Himley Village, Bicester

Phase 1B, Road Safety Audit - Stage 1 Designer's Response

Date 24 May 2024

Doc ref 27141-HYD-XX-XX-RP-C-0002-P01

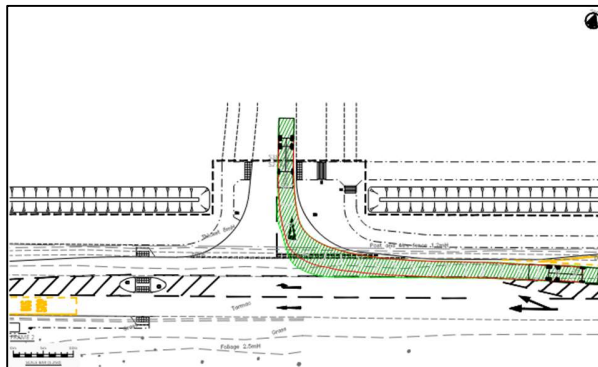
SUMMARY: Risk of NMU incursions into swale with risk of drowning

The scheme proposals include the provision of swales in close proximity to shared use facilities / cycleways and footways. From the information provided, some of the proposed swales are to be a minimum of 0.6m deep. With the absence of any features to protect NMU's from incursions into the swale, NMU's particularly cyclists may be at risk of exposure to level differences. This would be further exacerbated during periods of heavy rainfall where storm water may create a drowning hazard for any such incursions.

The Audit Team recommend providing measures to protect NMU's from incursions into the proposed swales throughout the scheme extents.

3.3	General to Middleton Stoney Road and internal roads The scheme proposals include the provision of swales in close proximity to shared use facilities / cycleways and footways. From the information provided, some of the proposed swales are to be a minimum of 0.6m deep. With the absence of any features to protect NMU's from incursions into the swale, NMU's particularly cyclists may be at risk of exposure to level differences. This would be further exacerbated during periods of heavy rainfall where storm water may create a drowning hazard for any such incursions.	The Audit Team recommend providing measures to protect NMU's from incursions into the proposed swales throughout the scheme extents.	DISAGREE: The swales are a maximum of 600mm deep in various locations. Each swale comprises a filter drain designed to store the surface water below ground from the storm up to a 1:30 year event. The swale will typically contain water in an extreme storm event for a short duration. No hazard mitigation is required.
